LICENSE SNM-928, CONDITION #27(e) CHANGE EVALUATION FORM

Cimarron Environmental Response Trust	
	Radiation Protection Plan	
Document No. RP-001	Rev. 0 [DRAFT A]	Effective date: 4/1/2011
		Page i

Figure 3-1

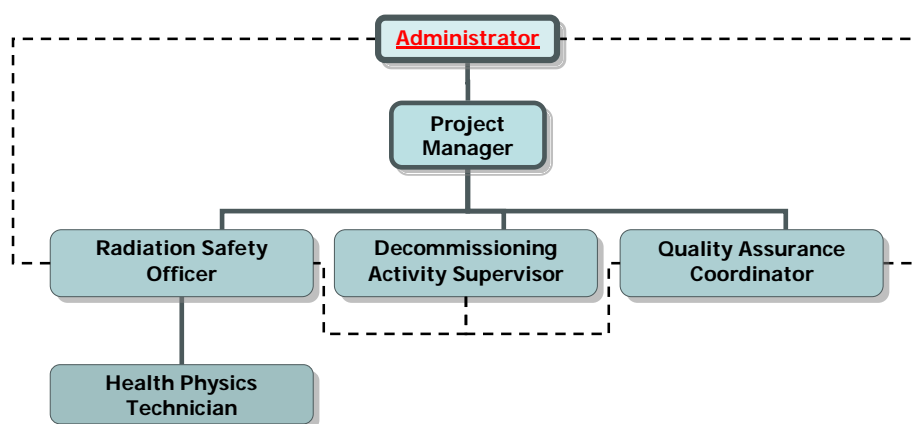
Comment [JJM2]: Change made to capture Cimarron Environmental Response Trust organization. Other conforming changes made throughout the RPP.

~~Cimarron Corporation~~ The Cimarron Environmental Response Trust Organization
